KMR.CDD.LyQ.1913.02

With reference to his application dated 17th instant, with a plan for building rooms on plot No.221, 222, K-7, Lyari quarter Mr.Dharamdas Premchand is informed, separate catch pits are required and access to the catchpit or latrines must not be through the main entrance to the compound , the latrines could be placed on the opposite side where a Roadway is available.

NOTICE UNDER SECTION 96 OF ACT III OF 1901.

The plan showing the rooms to be rebuilt on plot Nos 221 & 222 K.7 Lyaree Qr.

GROUND PLAN

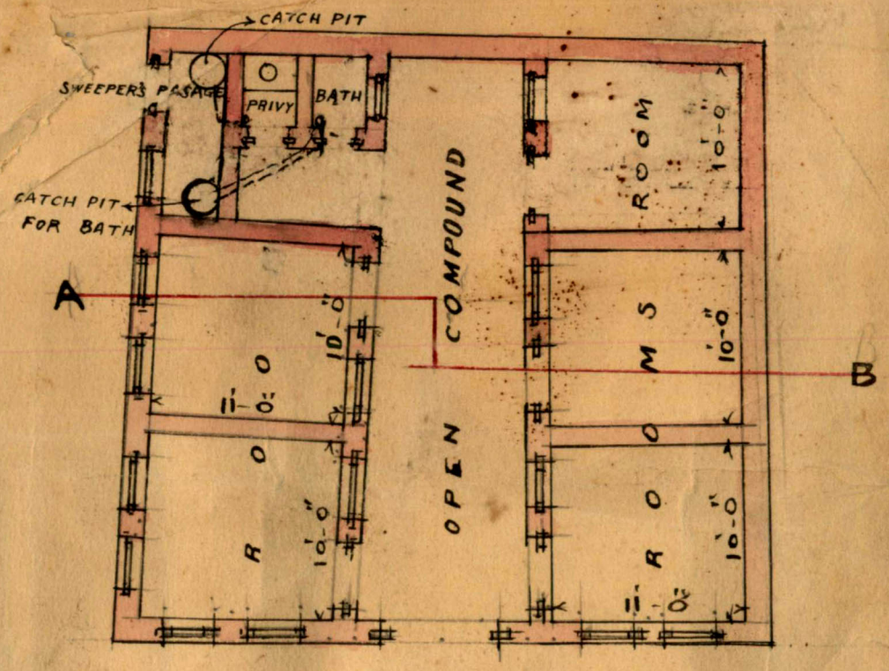
With ref. to his appl. 1176 E. with: was a plan for building rooms on plot nos 221+222 of Lyon Estate Dharamdas Premchand is informed, separate catchpits are required and access to the catchpits must not be through the main entrance to the compound, they could be placed on the opposite side where a roadway is available

applicant to be
informed separate
Catch pits are req^d
and access to the
catchpit or latrines
must not be through
the main entrance
to the Compound

Returned to the Engineer, Karachi Municipality, with the following remarks— Separate catchpits for bath & privy required. Sweep cannot have access through the compound. Sweeper's passage from the lane required. Separate catchpits for bathroom & privy not shown

With reference to your No E. 534 dated 31/3 January 1913 I beg to state the plot No 222 K.J. Lyari quarter will be build as ordered by your honour viz separate and new catch pits will be erected on each main entrance to the compound as desired.
